SUBJECT: Permit Modification Request for Section 404 Individual Permit and Section 401 Individual Water Quality Certification for the new location facility from SR 2011 to the Haw River at US 220, Greensboro, Guilford County; Division 7; TIP No. R-2413A/B

The North Carolina Department of Transportation (NCDOT) awarded the design-build team this project on April 8, 2014 to construct projects R-2413A, R-2413B, and I-5110. Sections R-2413A and B were authorized by the USACE and NCDWR as referenced above. We are requesting a modification in the permits for a new impact area: Permit Site 24 in Section R-2413A.

Permit Site 24. Impacts were avoided in the original design at this stream crossing as the plans called for a gravity wall to carry the extra lane. However, further geotechnical analysis determined that due to stability issues, neither the gravity wall nor other options (MSE, pile panel, etc.) were viable as they would impact either existing traffic on NC 68 or the pipes under NC 68. Therefore, the only option is to extend the pipes under NC 68, which will result in impacts of 15 LF of permanent fill, 31 LF of bank stabilization, and 10 LF of temporary fill in surface waters. Pl

PROJECT REFERENCE NO. R-2413A	SHEET NO. 6
ROADWAY DESIGN ENGINEER	HYDRAULICS ENGINEER
DOCUMENT NOT CONSIDERED FINAL UNLESS ALL SIGNATURES COMPLETED	
ADDED PERMIT SHEET 1A OF 81	
3/18/2016 DRAWING 1A OF 81

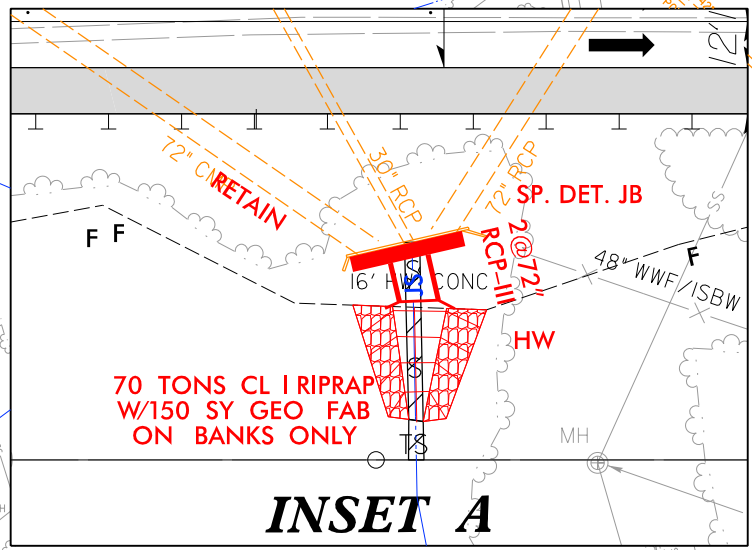
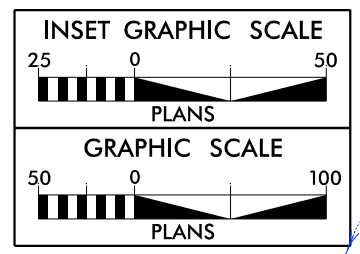
SITE 24
SEE INSET A

PROJECT REFERENCE NO. R-2413A	SHEET NO. 6
ROADWAY DESIGN ENGINEER	HYDRAULICS ENGINEER
DOCUMENT NOT CONSIDERED FINAL UNLESS ALL SIGNATURES COMPLETED	
ADDED PERMIT DRAWING SHEET 3/18/2016 3/18/2016 IB OF 81

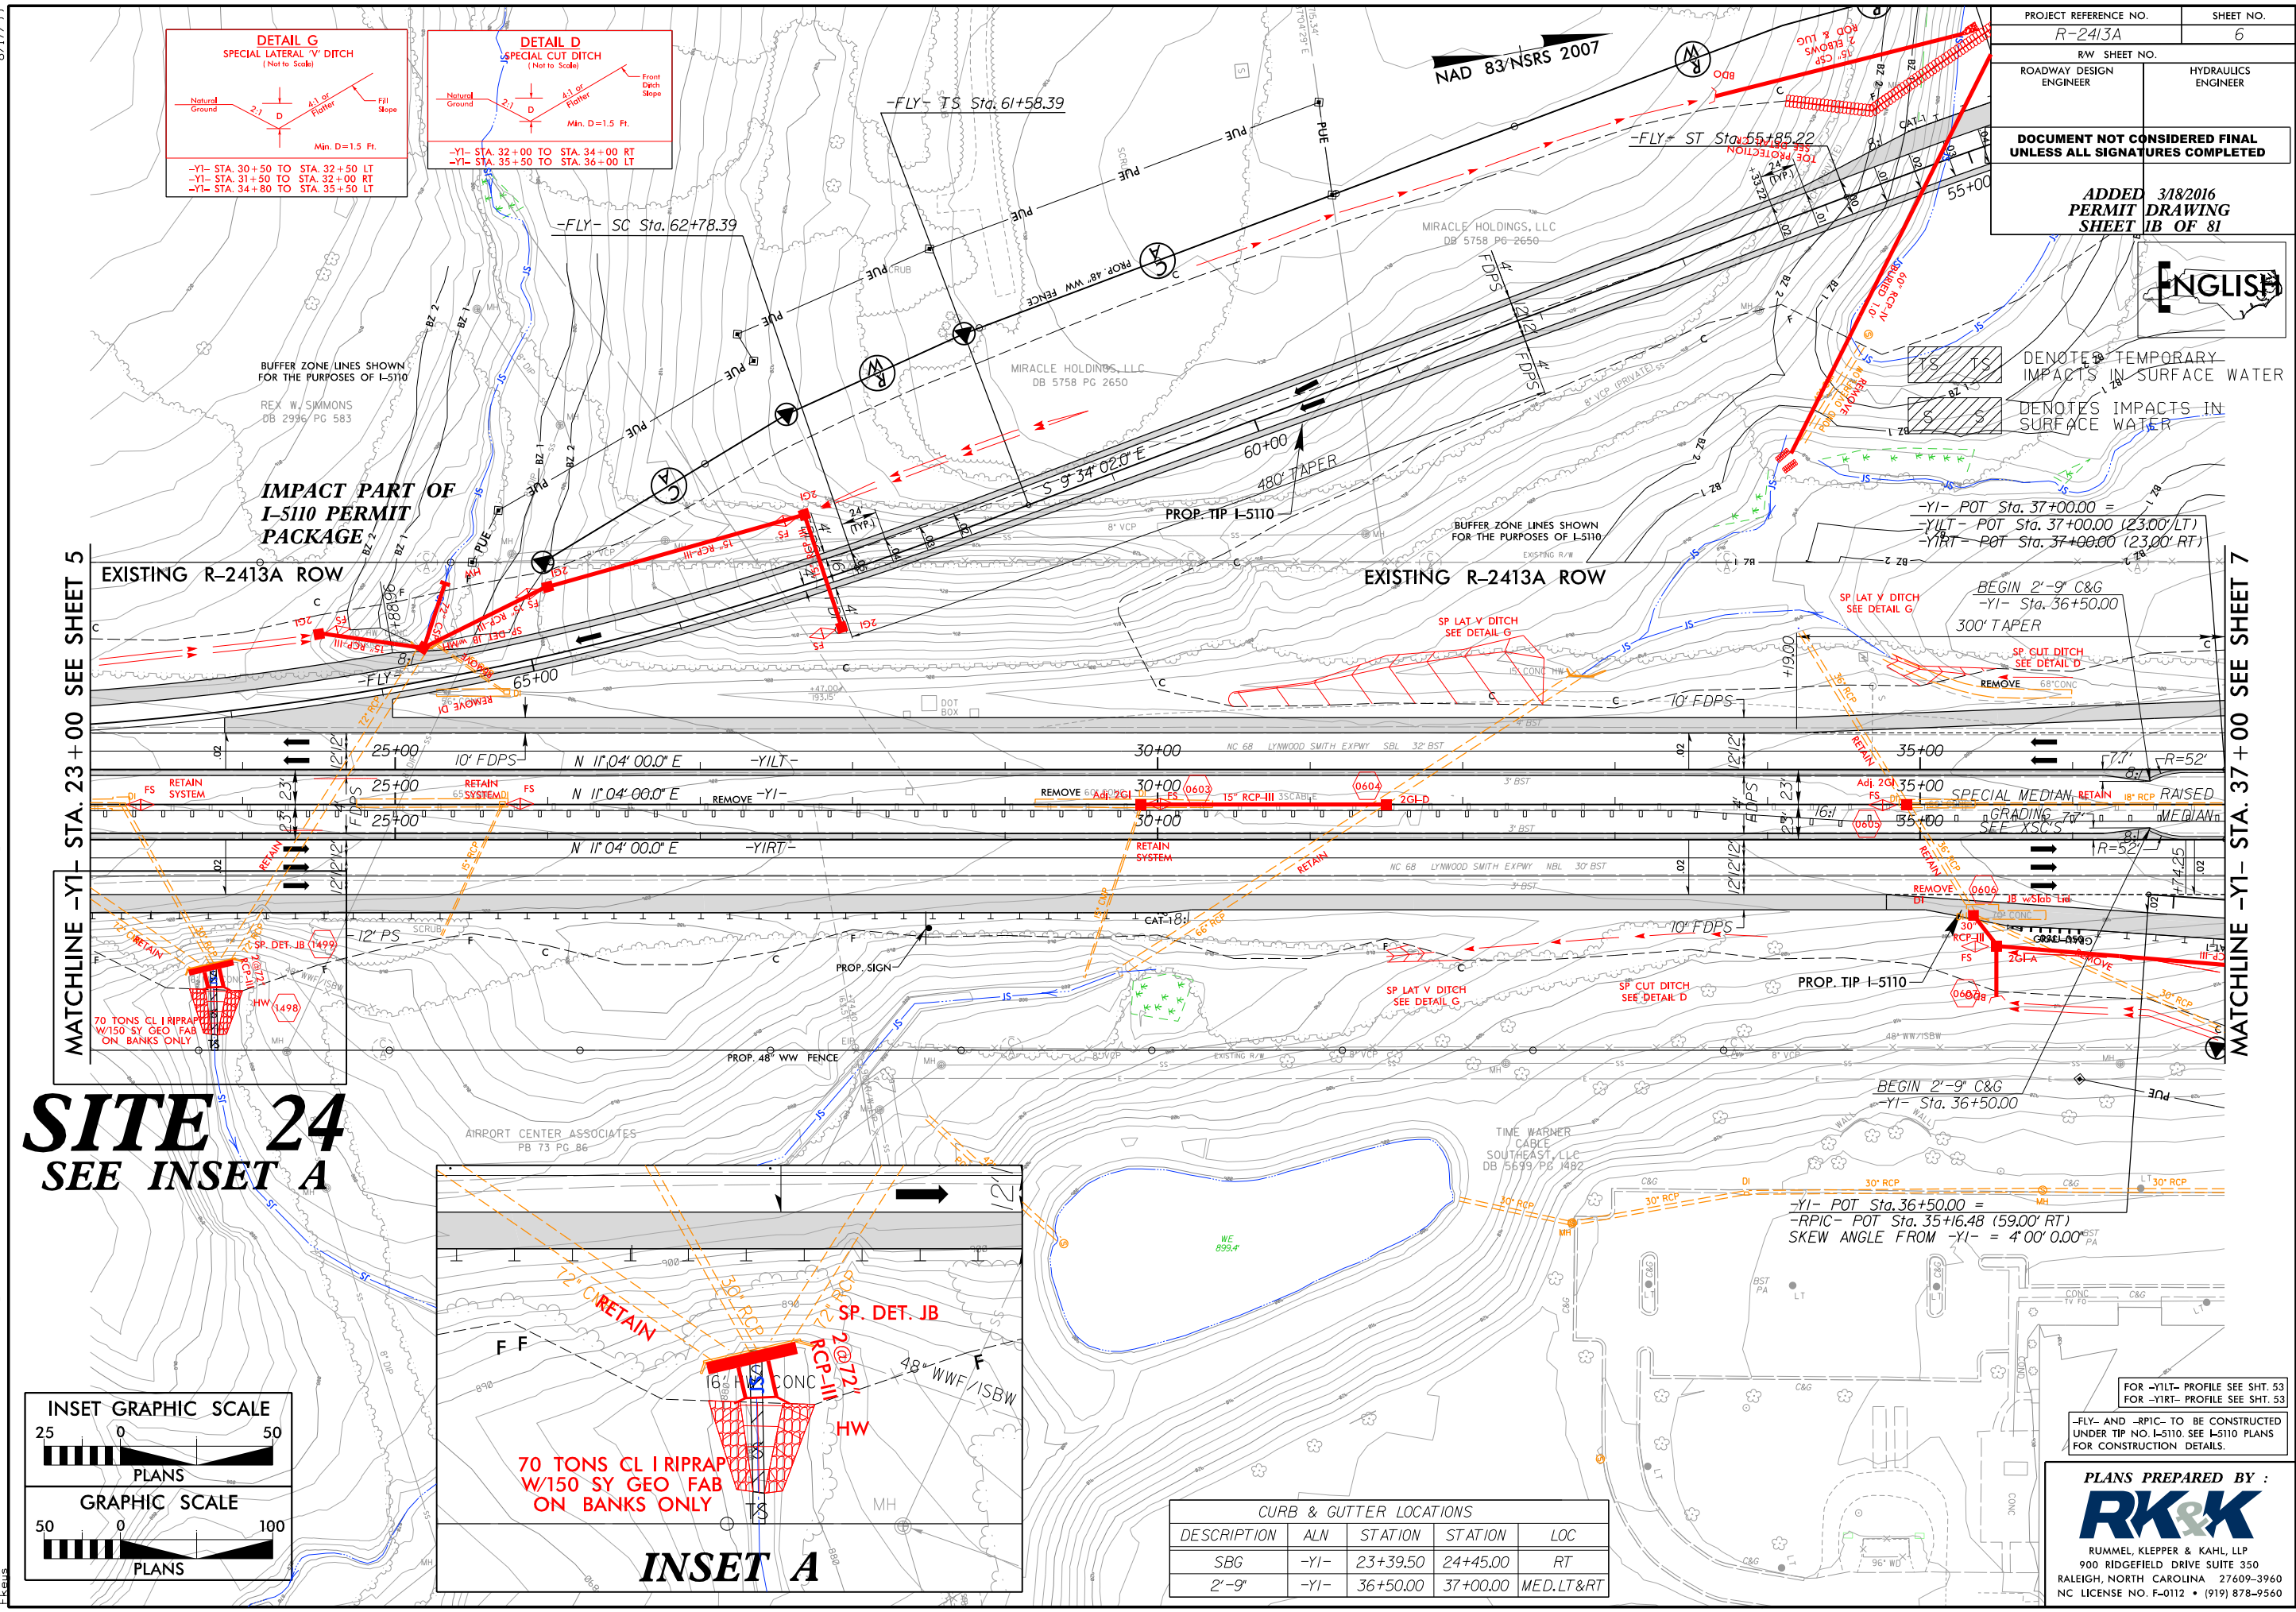
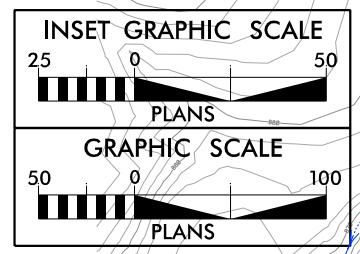
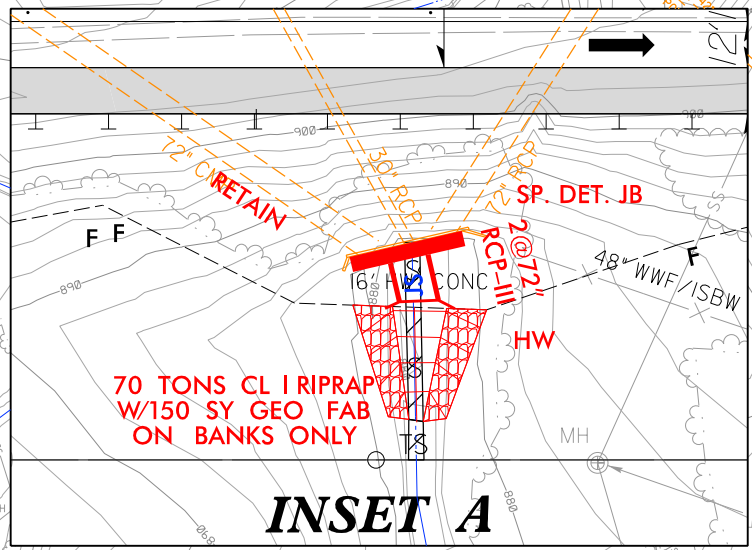
SITE 24
SEE INSET A

PROJECT REFERENCE NO. I-5110	SHEET NO.
ROADWAY DESIGN ENGINEER	HYDRAULICS ENGINEER
ADDED PERMIT SHEET	03/18/2016 DRAWING IC OF 81

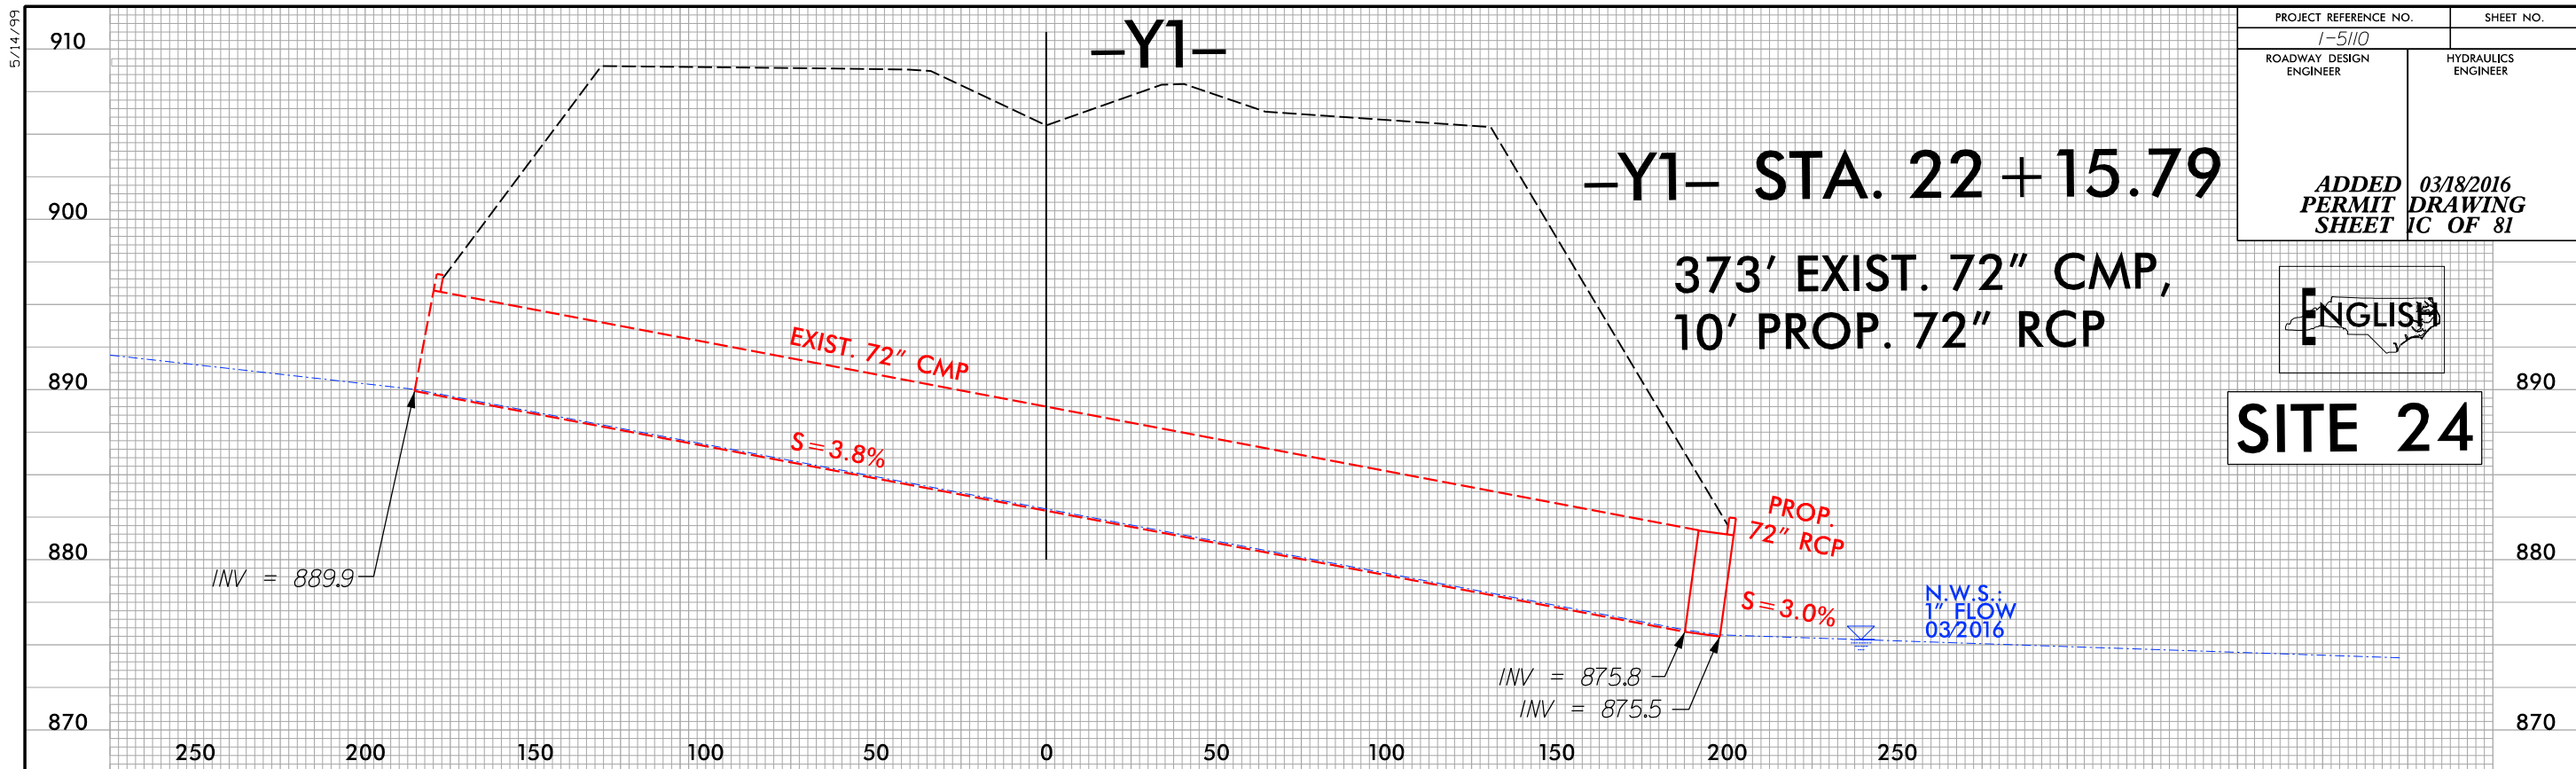
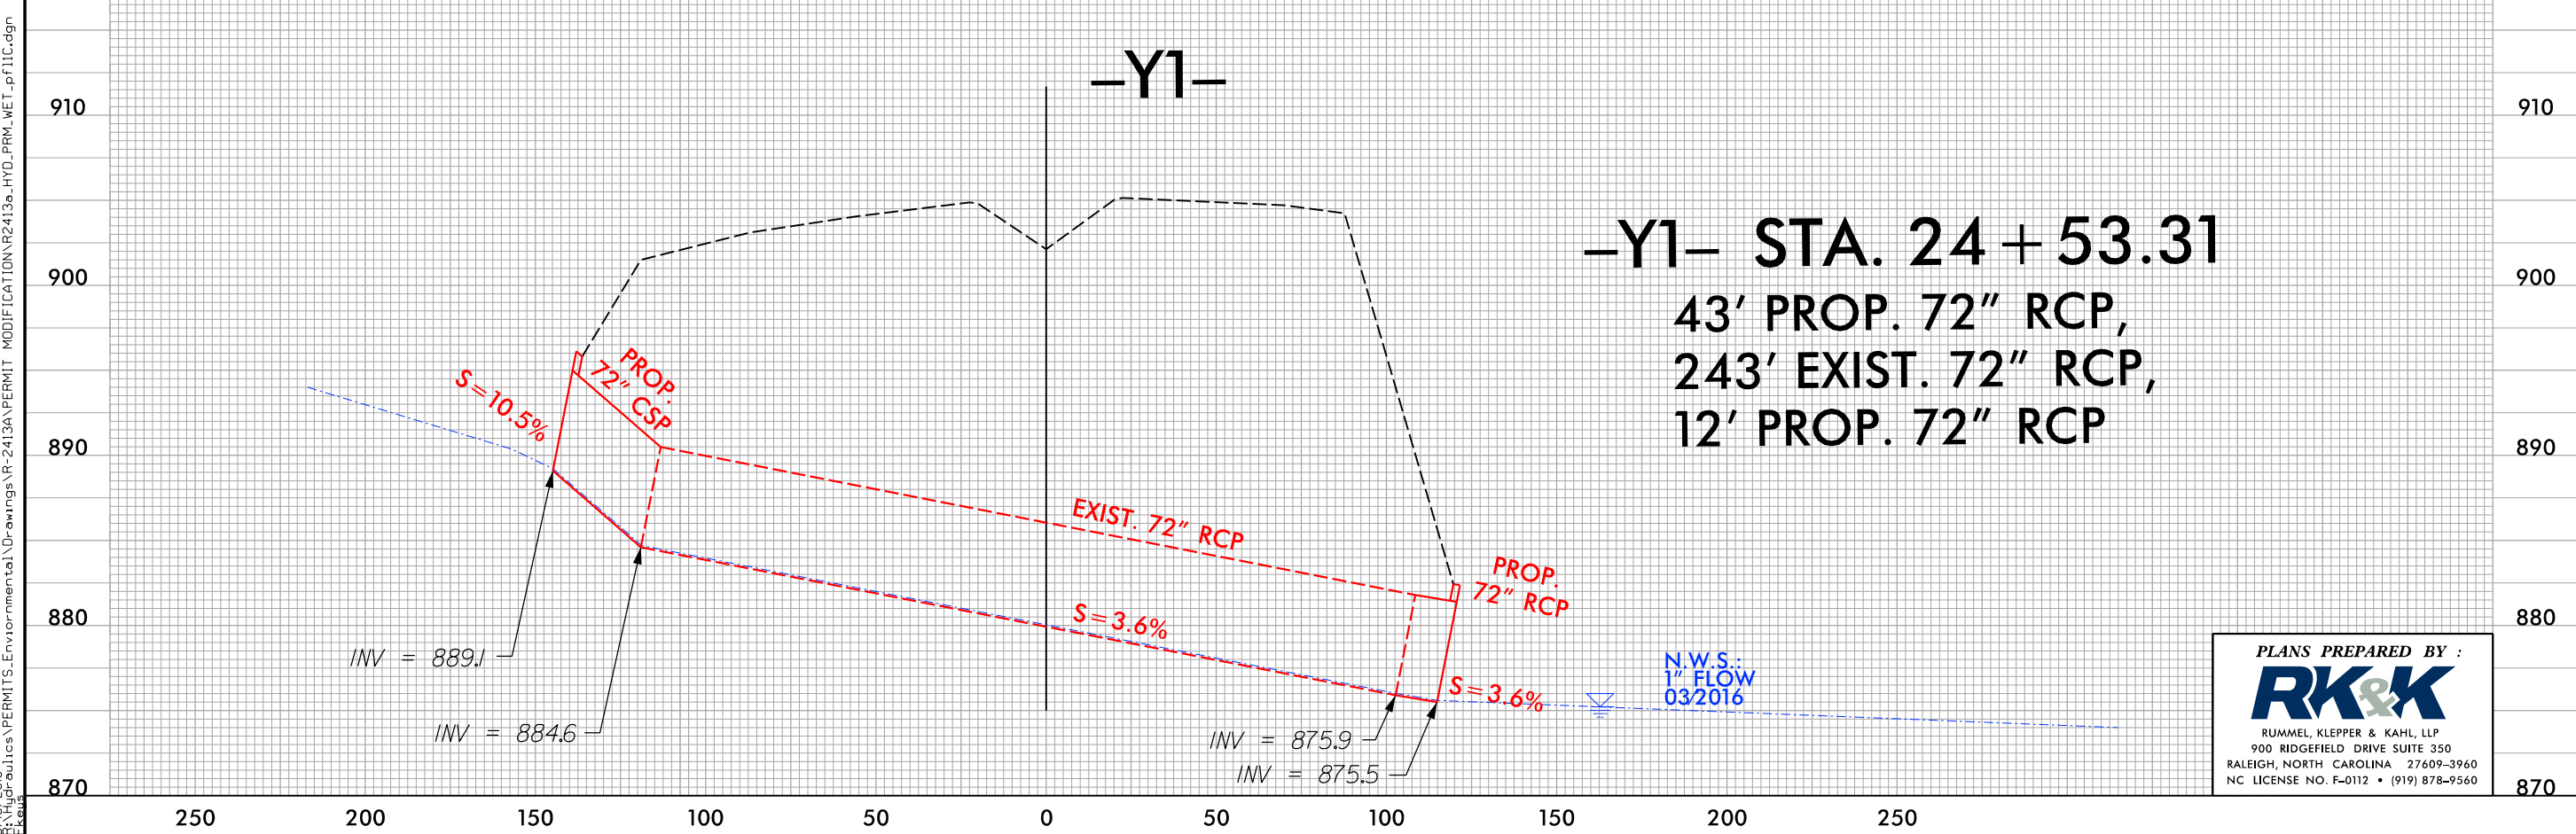
SITE 24

-Y1- STA. 24 + 53.31
 43' PROP. 72" RCP,
 243' EXIST. 72" RCP,
 12' PROP. 72" RCP

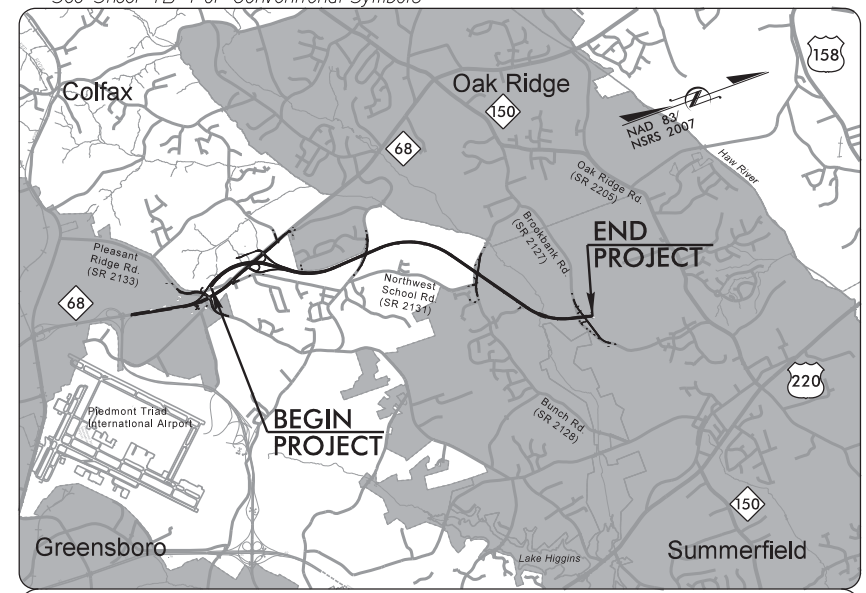
As noted on the revised summary table impacts for R-2413 Section A (drawing 81 of 81) there are 8,993 LF of permanent impacts and 977 LF of temporary impacts to jurisdictional streams.

Note: In the May 26, 2015 permit modification, 10 LF of permanent stream impacts due to bank stabilization for Site 7A (drawings 21-23 of 81) were added to the Permit Summary Impact table, but inadvertently not carried down to be included in the overall Project TOTALS cell of the Existing Channel Impacts Permanent (FT) column. This oversight has been corrected on this submittal.

** PERMANENT FILL IN WETLAND IN ORIGINAL PERMIT WAS SUMMED WRONG. IT WAS LISTED AS 3.13ac; IT SHOULD HAVE BEEN 3.14ac

*** TEMP CHANNEL IMPACT IN ORIGINAL PERMIT WAS SUMMED WRONG. IT WAS LISTED AS 922'; IT SHOULD HAVE BEEN 952'

Bank Stabilization						<0.01		31		
SUBTOTALS:			2.57	0.04		0.16	0.13	0.14	0.13	1423	530	250
TOTALS:			3.11 **	0.04	<0.01	0.19	0.13	0.78	0.29	8993	977 ***	2390
